Recall Campaign

NHTSA#: 13V-558

Add stop plate to the lifter system mechanism

2011 CAMPING TRAILERS

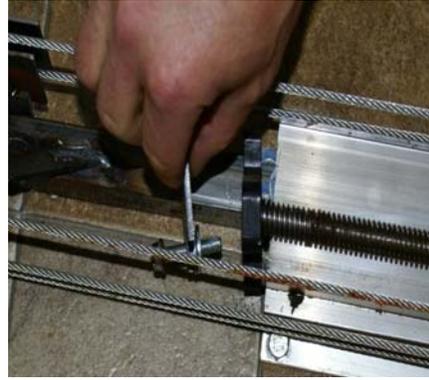
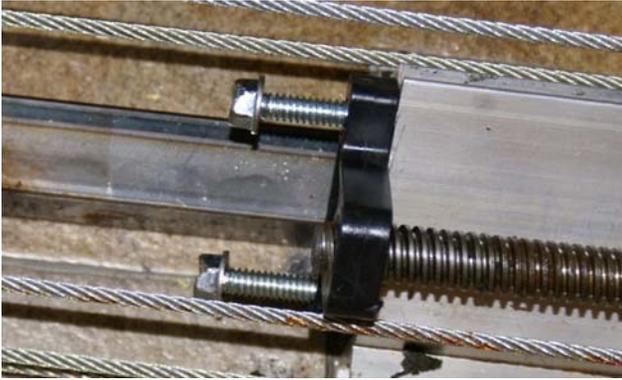
2. Once you have gained access, locate the lifter system actuator (end) piece (**Fig. 1a**).

3. Using a 3/8" socket, remove the (2) screws that hold the actuator in place. Remove the tailstock (end piece).

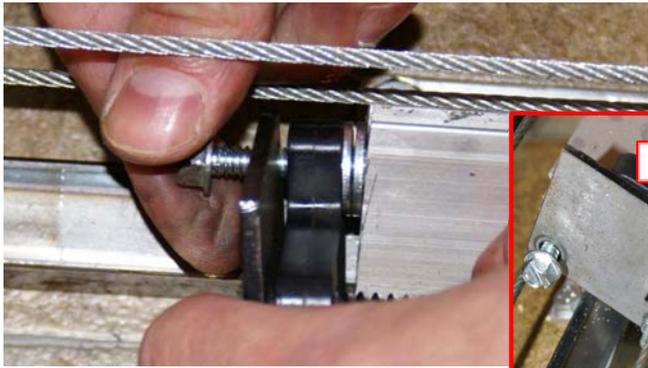
4. Insert the screw through the hole in the plate, the corresponding hole in the tailstock and then add (2) washers. Re-install the screw into the corresponding hole and screw it into place just enough to hold it in place. Insert the second screw through the holes in the other side of the plate and the tail piece. Add (2) washers to the back side of the tailstock.

NOTE: Looking at the plate, the notch should be on the right side so the plate doesn't restrict or touch the cable (Fig. 4a).
